## DESCRIPTIVE REPORT

Type of Survey .. Hydrographic ..  
Field No. .... PHP-10-1-89 ..  
Registry No. ... H-10293 ..

State ..... California ..  
General Locality Grizzly Bay ..  
Sublocality ... Suisun Slough to ..  
..... Simmons Island ..  
..... 19 89 ..  
CHIEF OF PARTY  
LT F. Diaz ..

**HYDROGRAPHIC TITLE SHEET**

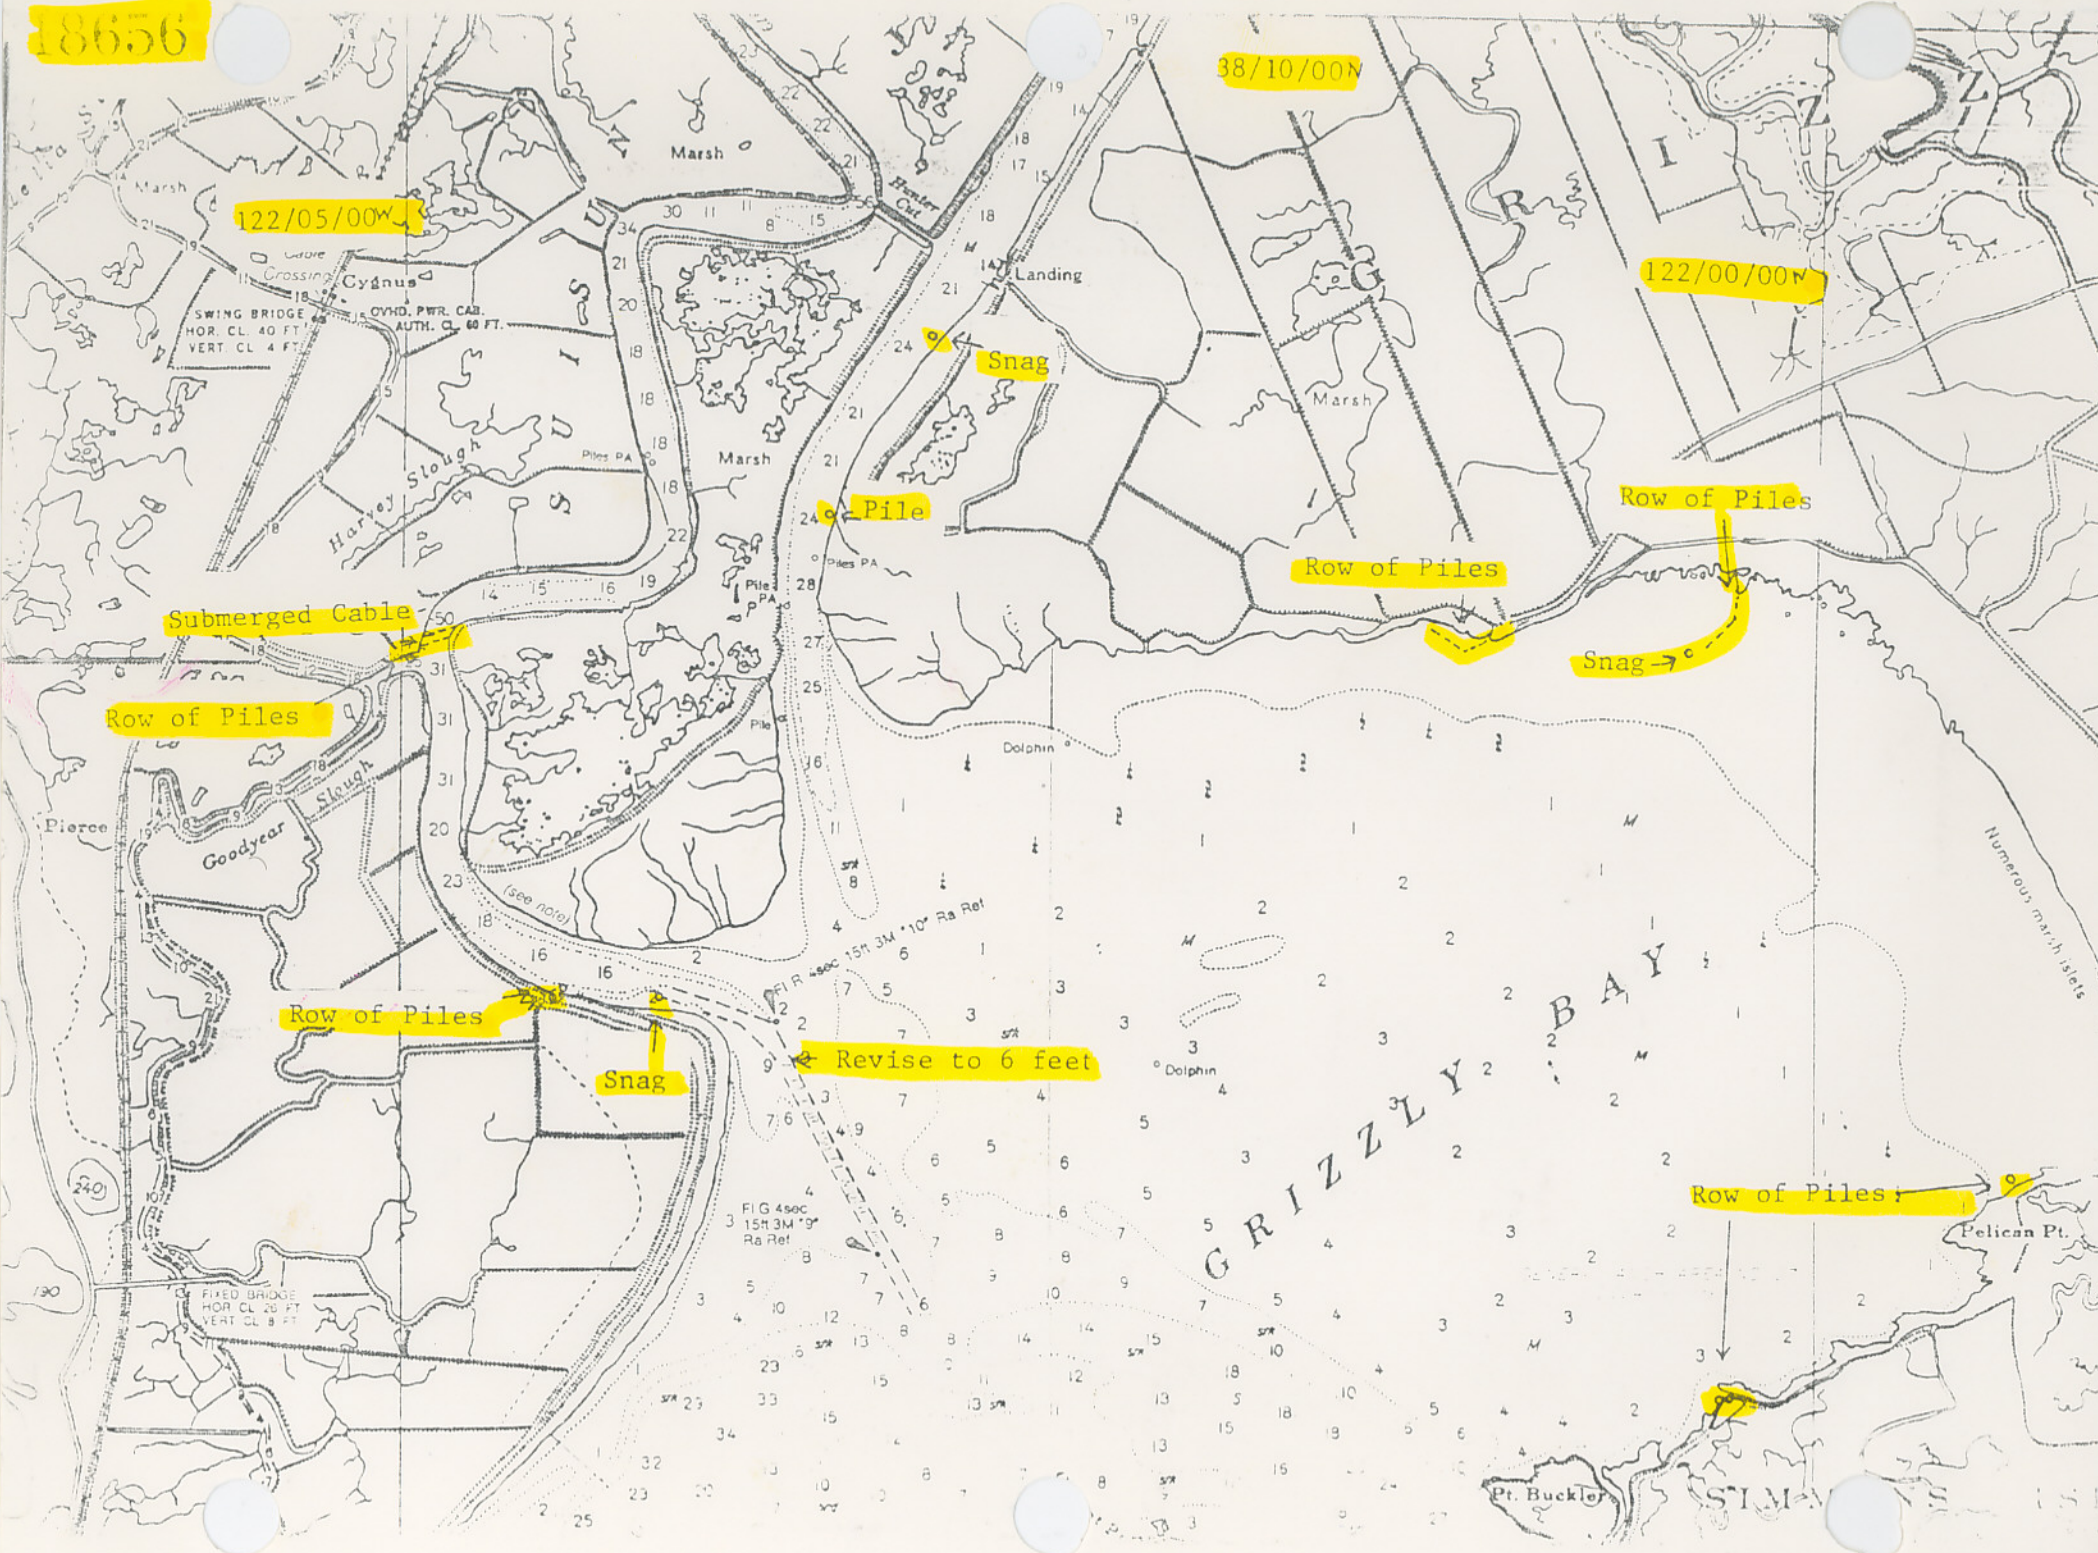
Row of Piles

Row of Piles

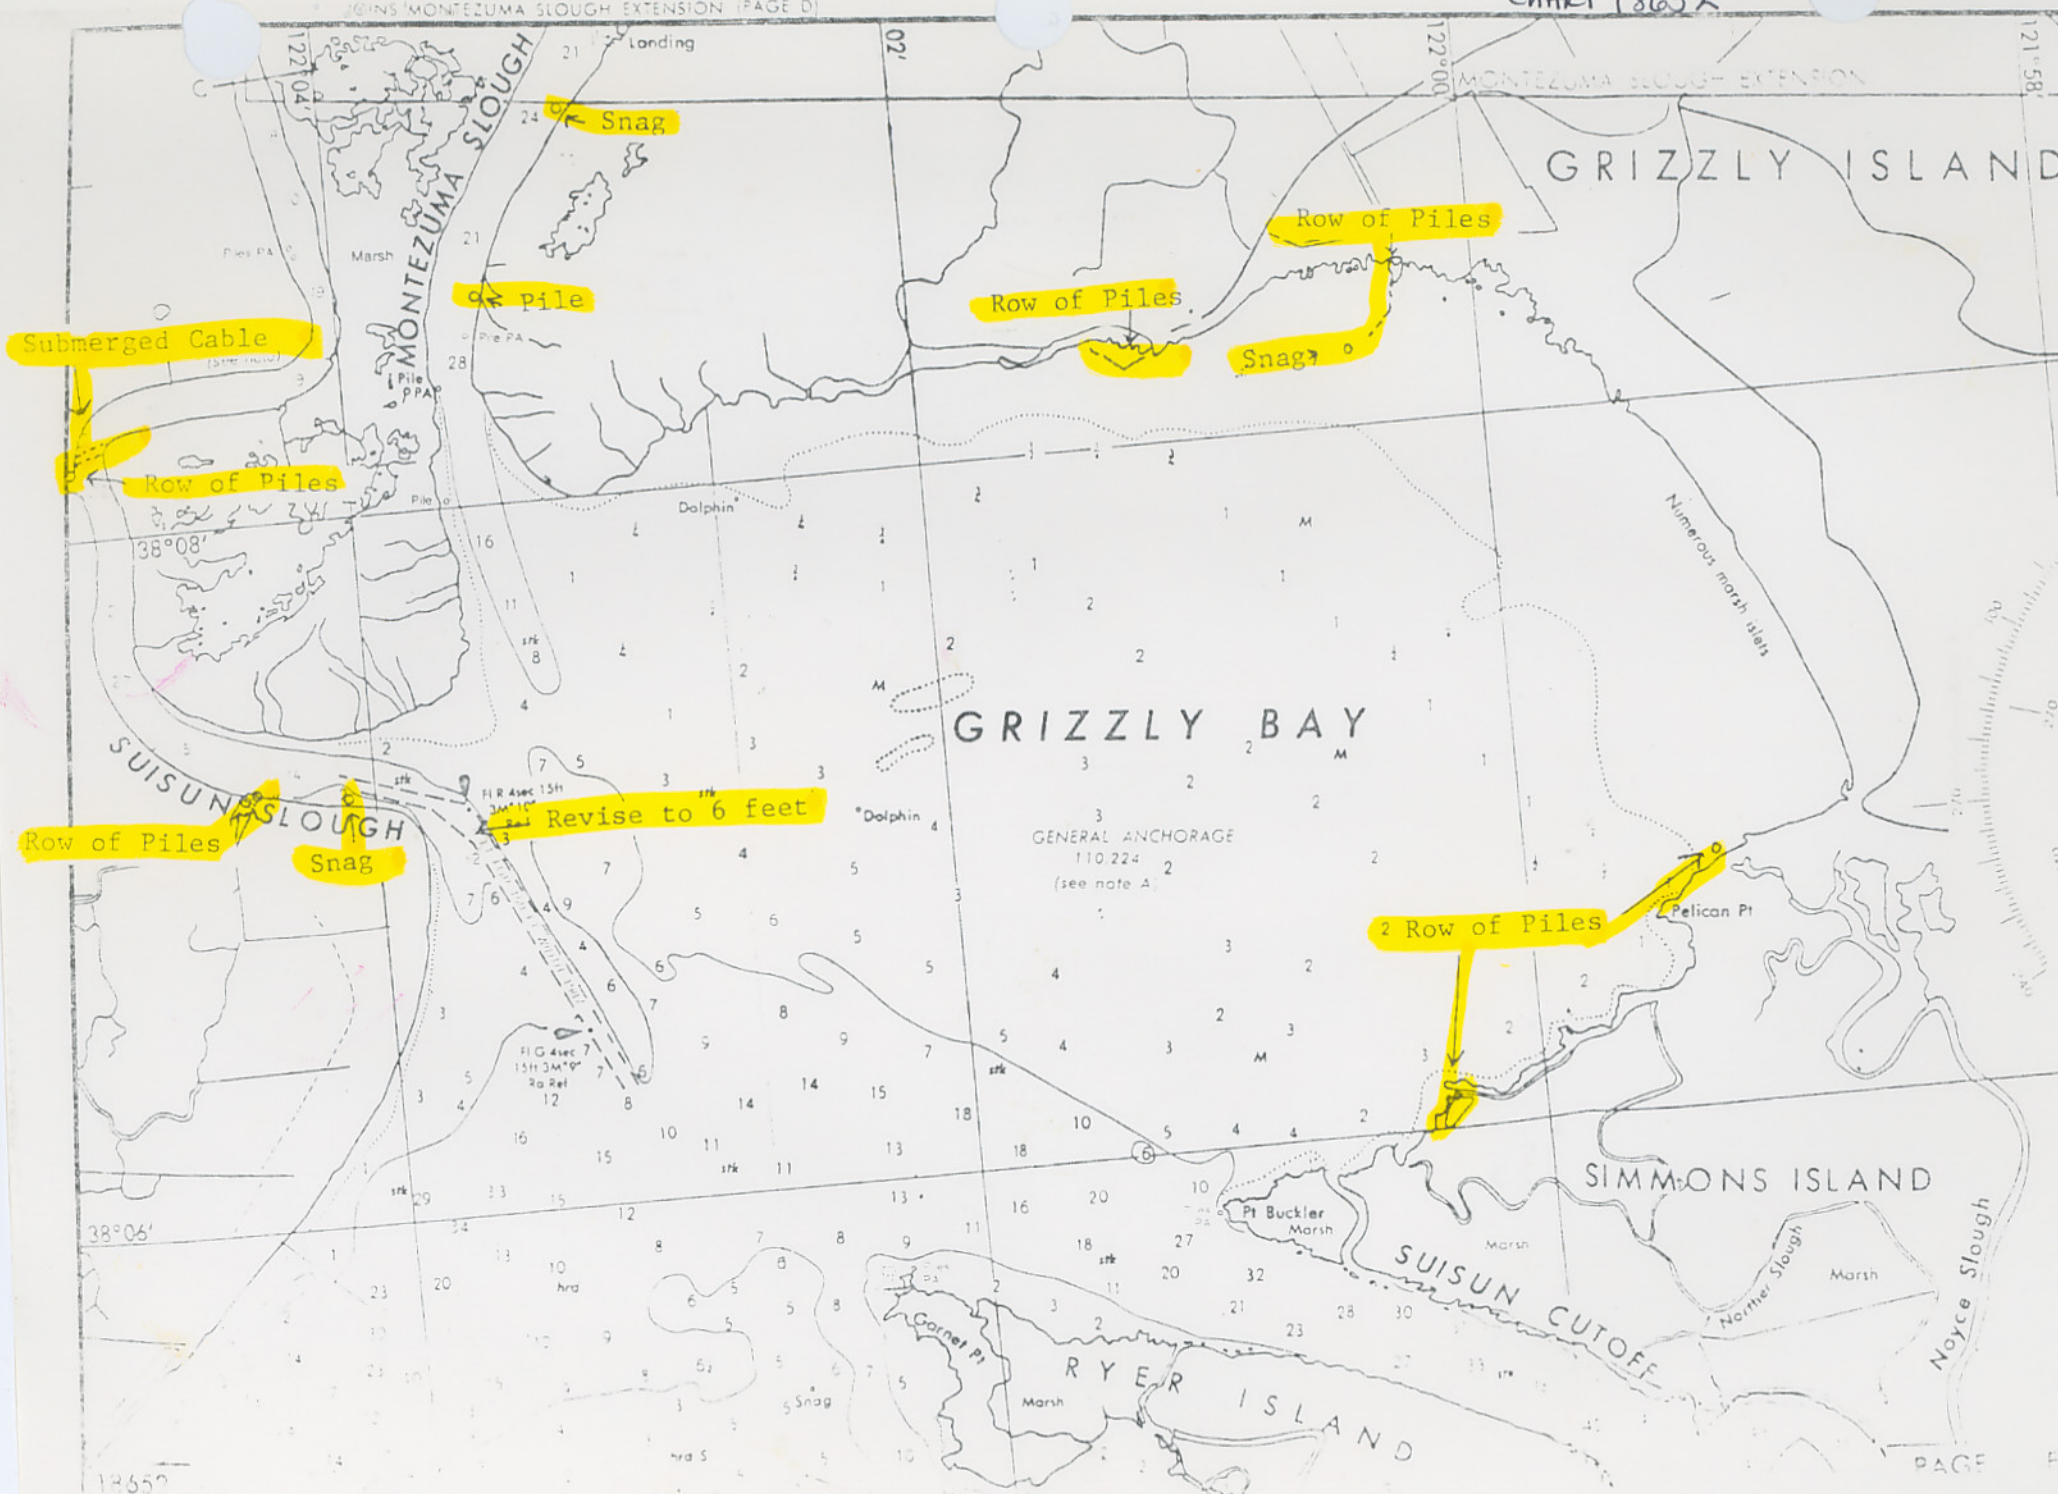
Snag →

75-METER RADIUS BOTTOM CIRCLE DRAG

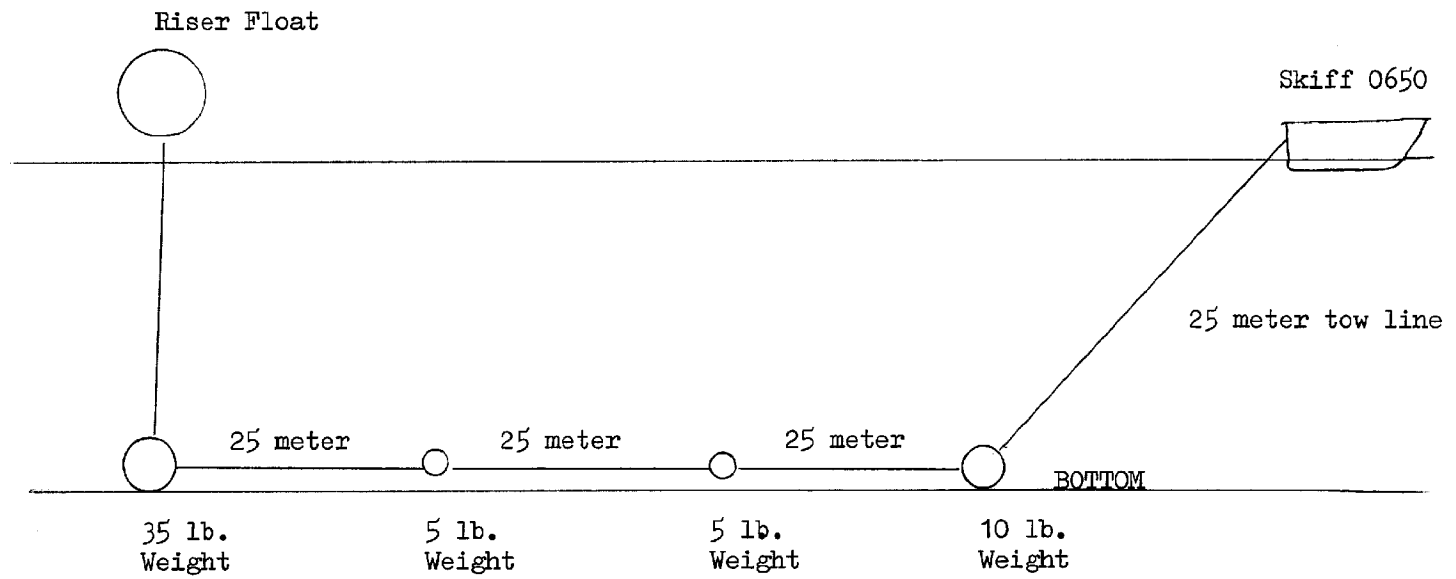
Row of Piles

Snag

← Revise to 6 feet

Row of Piles
